GMN is introducing the tolerance class P4+. This tolerance alleviates the need for any additional; high marking, grading, or matching. This is a direct cost savings to your bottom line! The P4+ is being phased in through 2016 into 2017 across the entire super precision angular contact bearing range.

PN = HYS 6006 ETA P4+ UL

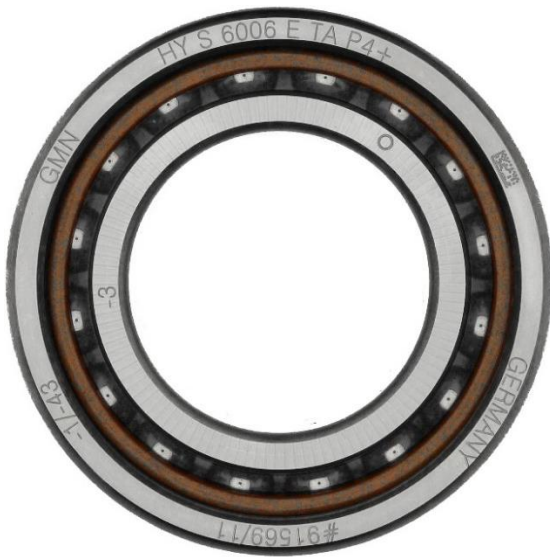
The same quality you expect from GMN will continue, but with additional tolerancing printed right on each bearing box and each bearing. ID, OD, and width deviations are all present along with an inner race high point mark. Please see the examples below and feel free to contact GMN USA with any questions.

ID = -3 microns below nominal

OD = -1 micron below nominal

Width = -43 microns below nominal

IR High Point = ~1 O'clock within example
